Final Drainage Report
for
WindingWalk Filing 2
at
Meridian Ranch

EL PASO COUNTY, COLORADO

July 2018

SF-18-022

GIECK. HISTORIC

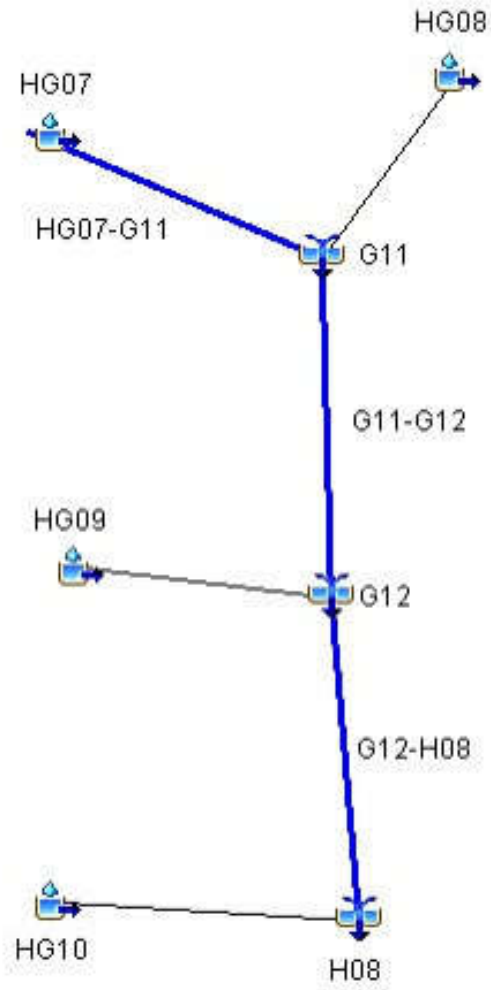
Add a footnote identifying what the green and yellow highlight means.

Figure 4 - Meridian Ranch Rational Basin Map

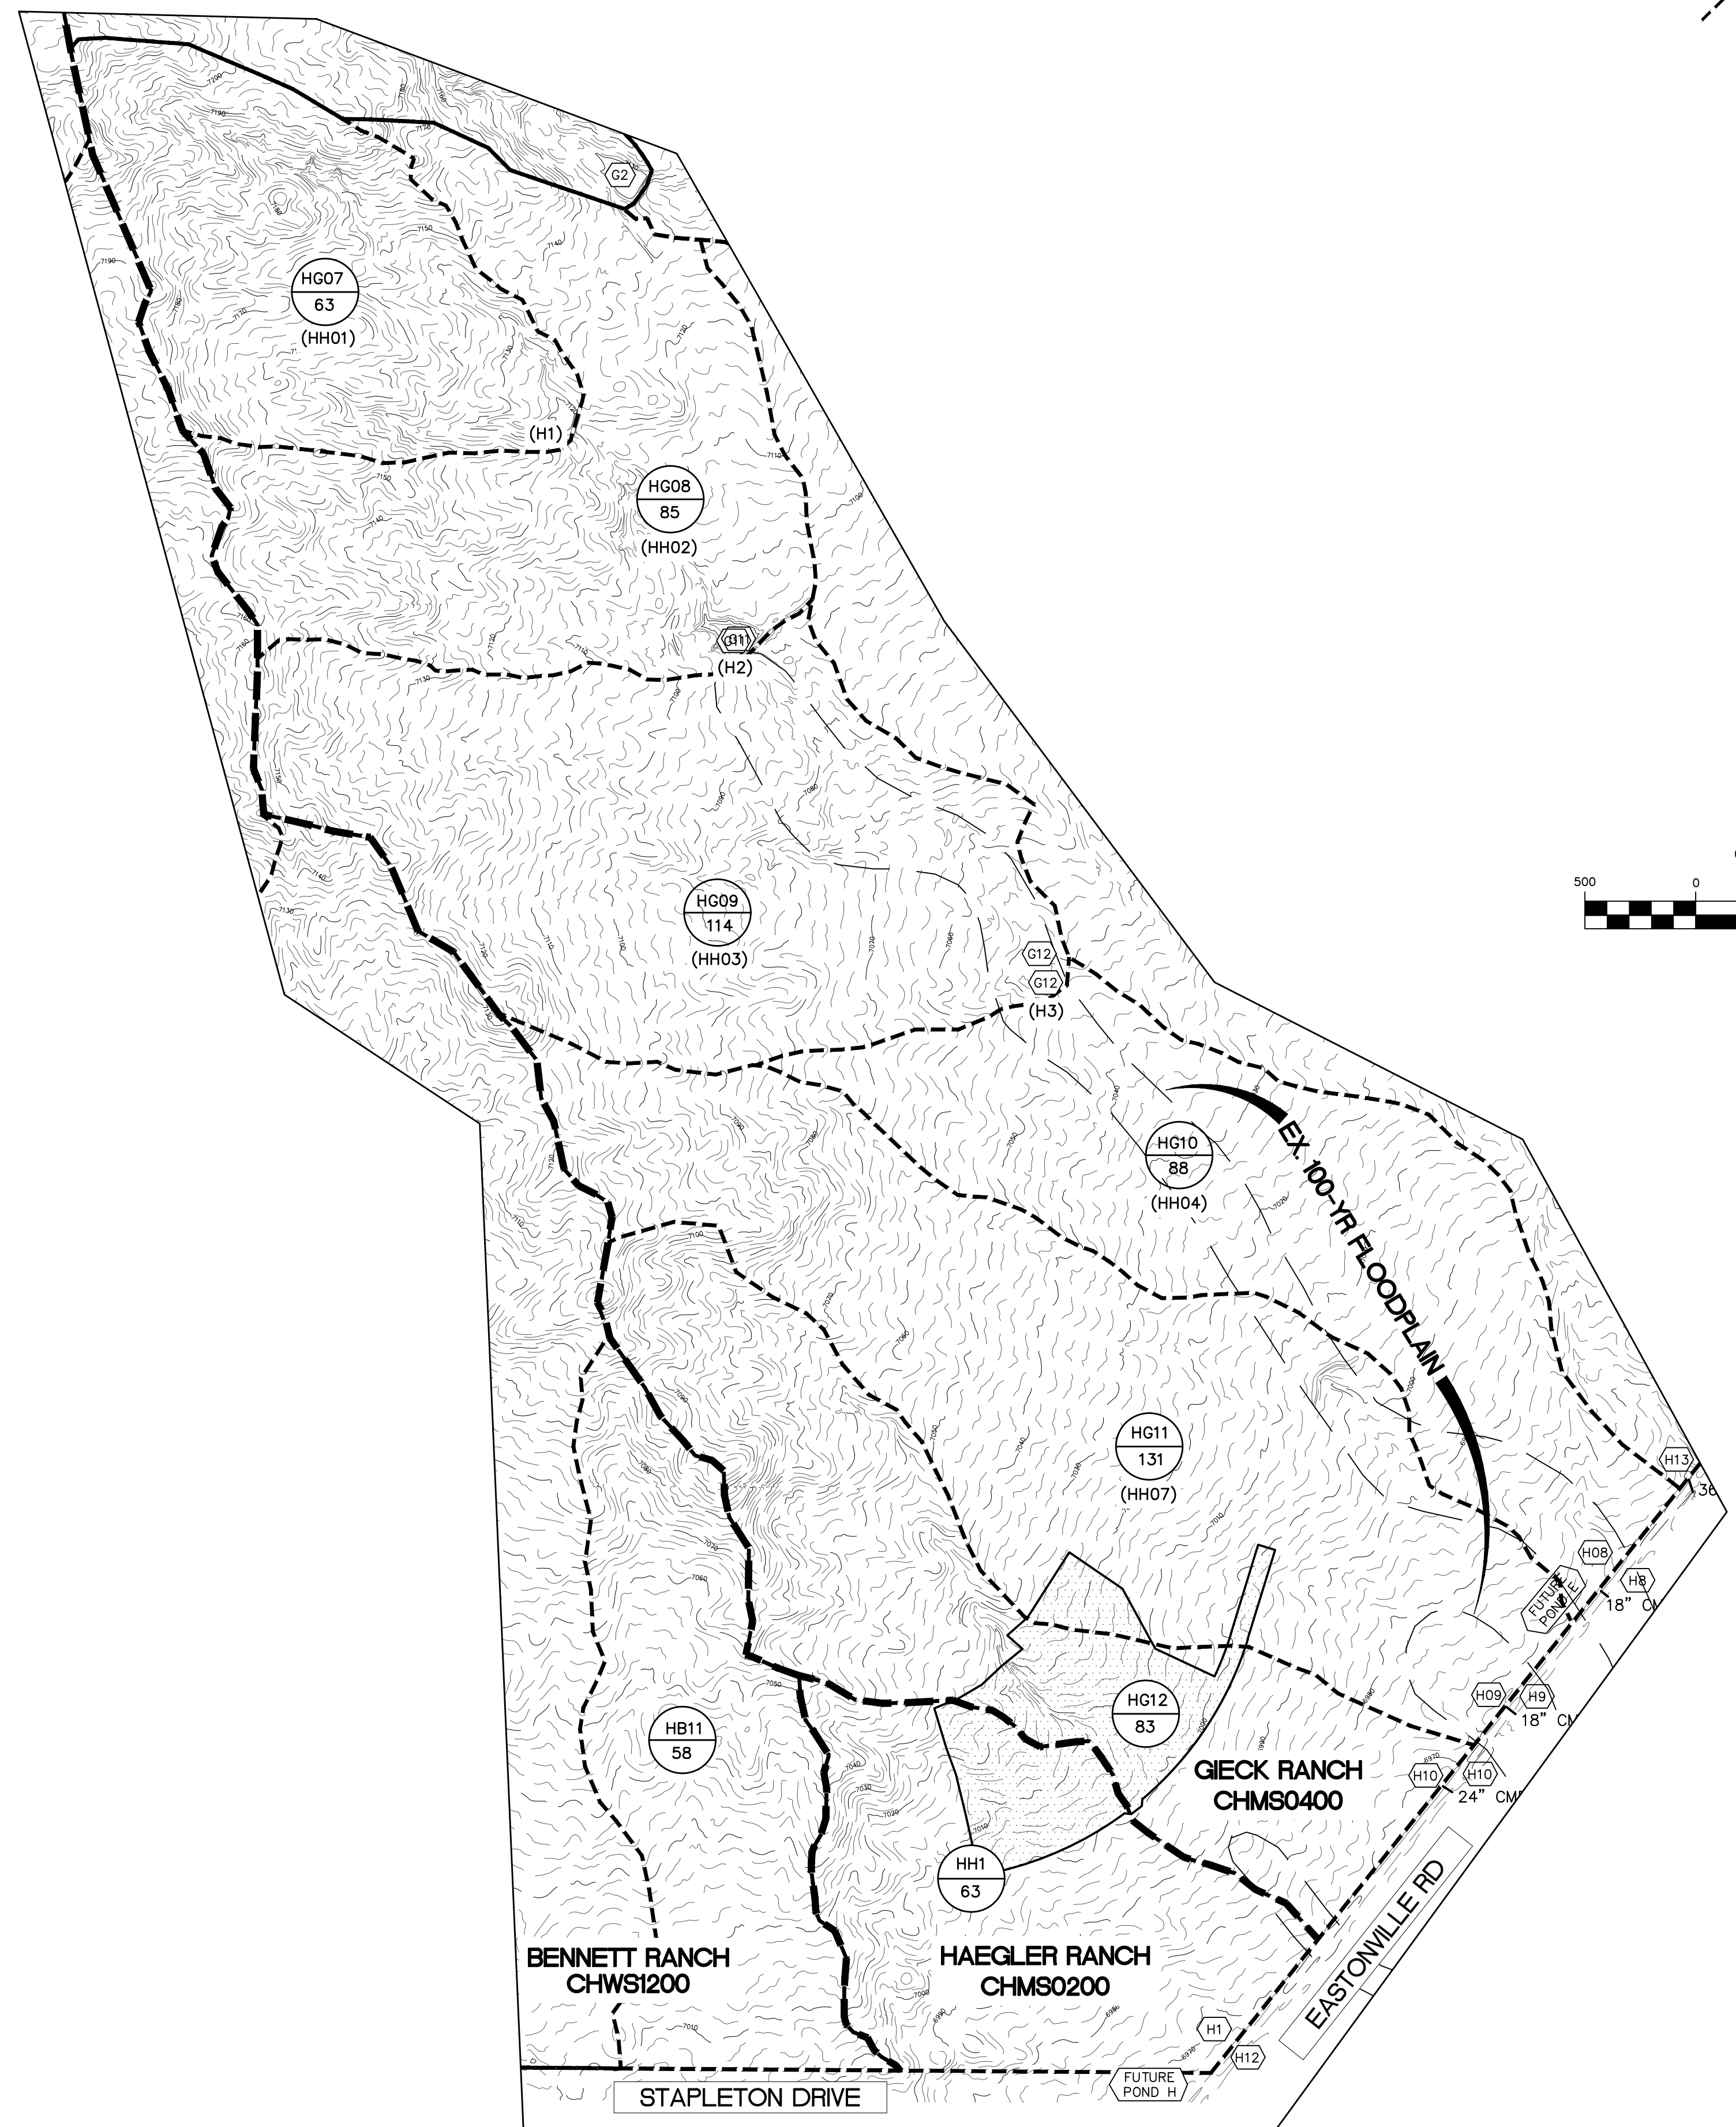
Add the hatching in the legend. Staff recommends highlight the site so be immediately distinguished as the project site location.

FUTURE CONDITIONS

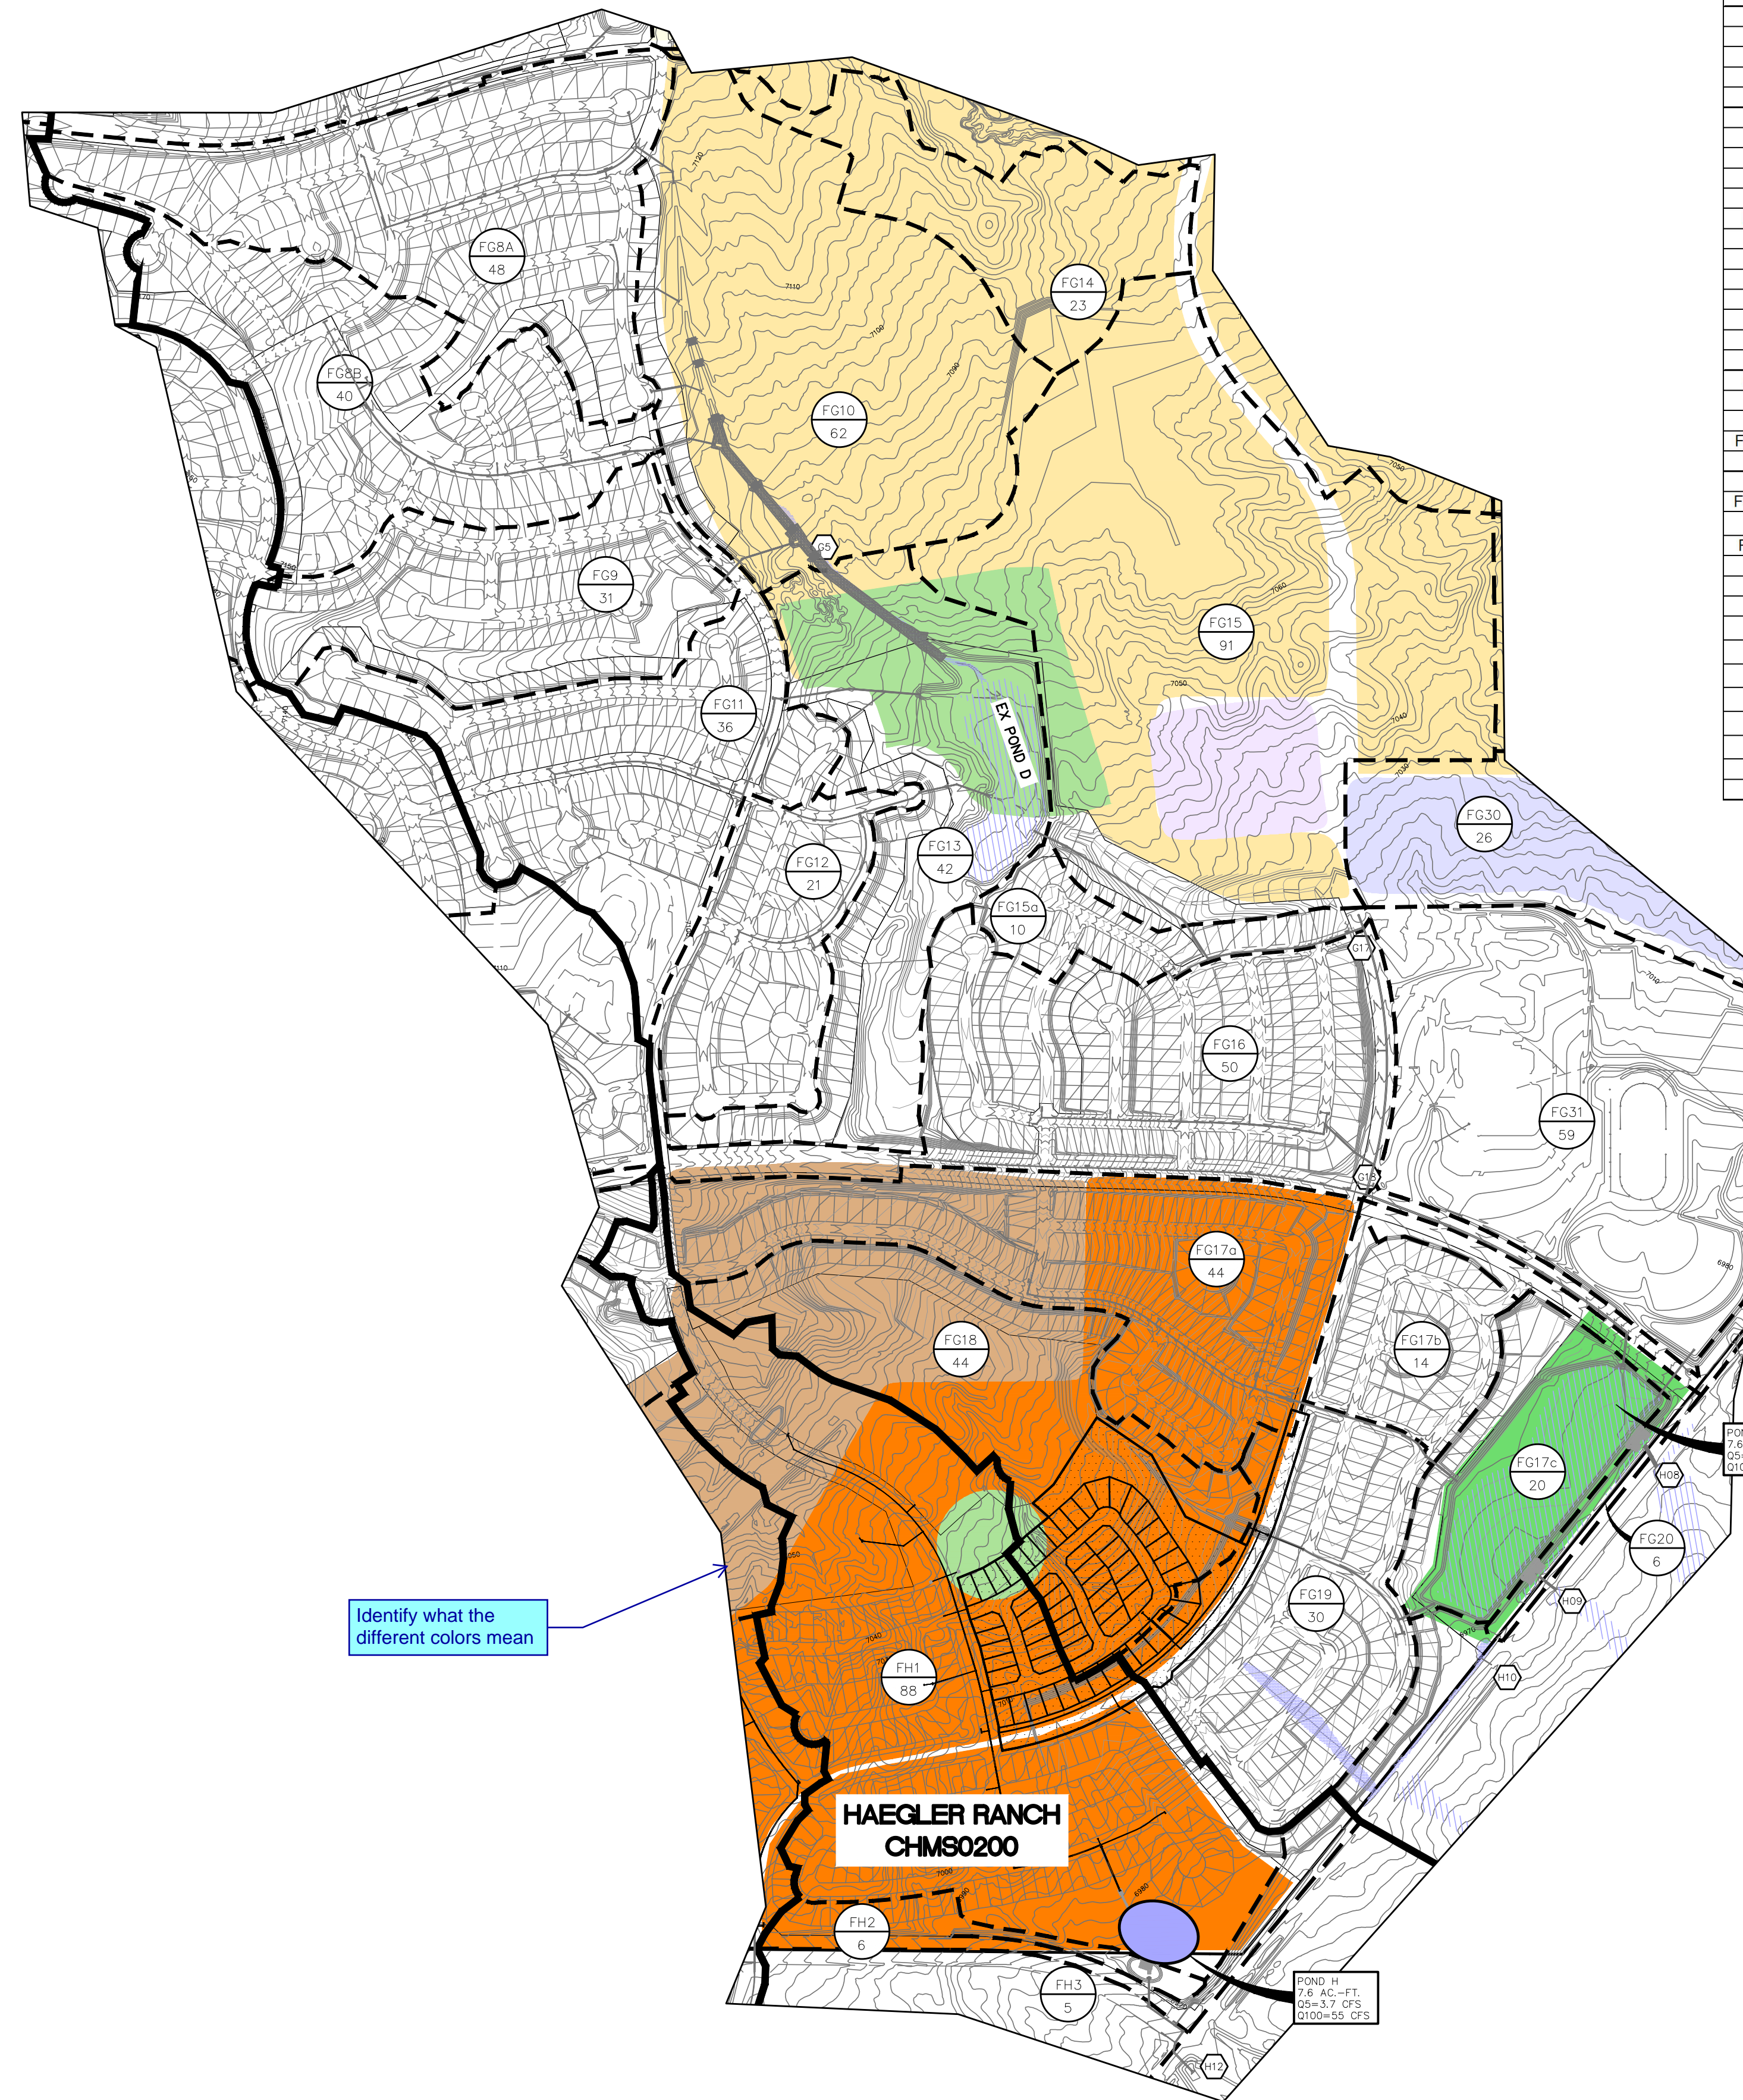
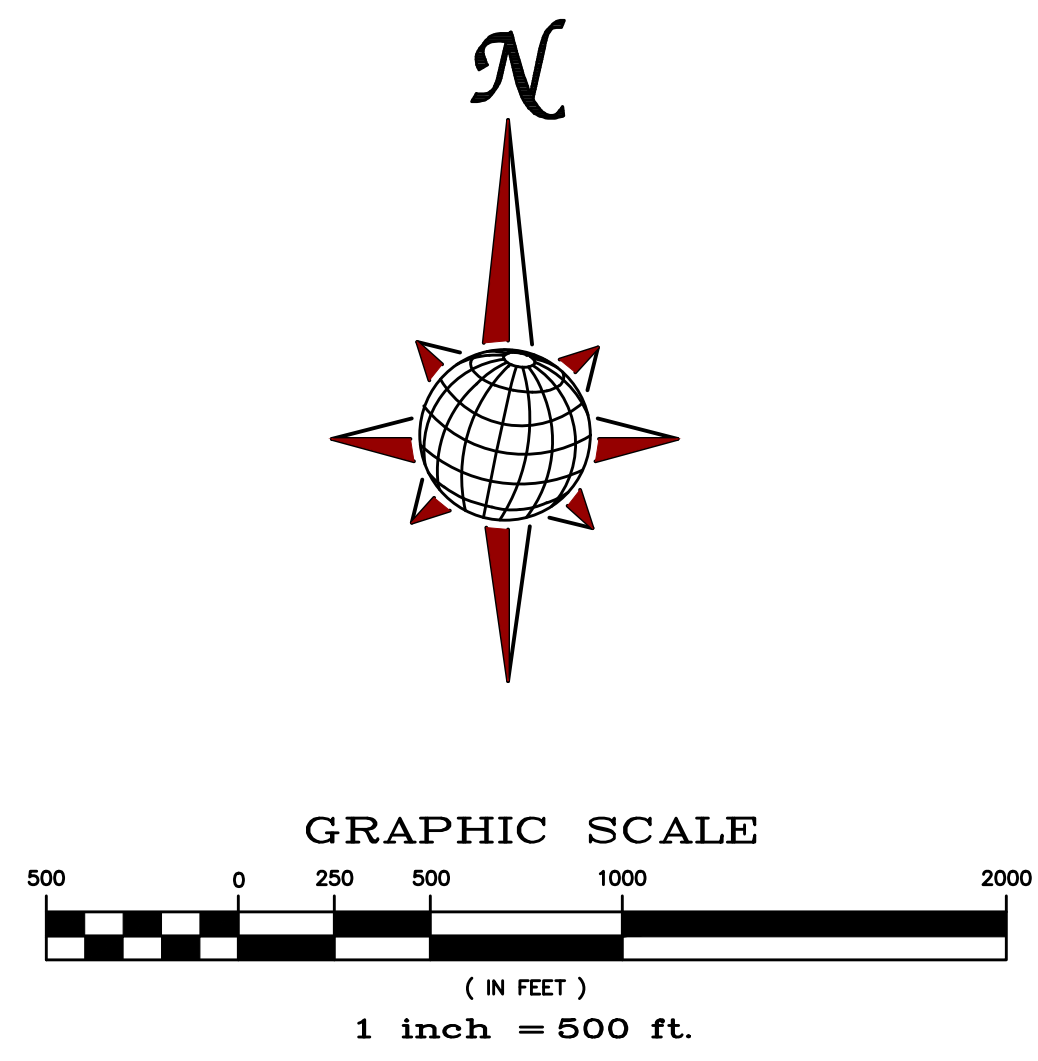
Remove the Winding Walk 3
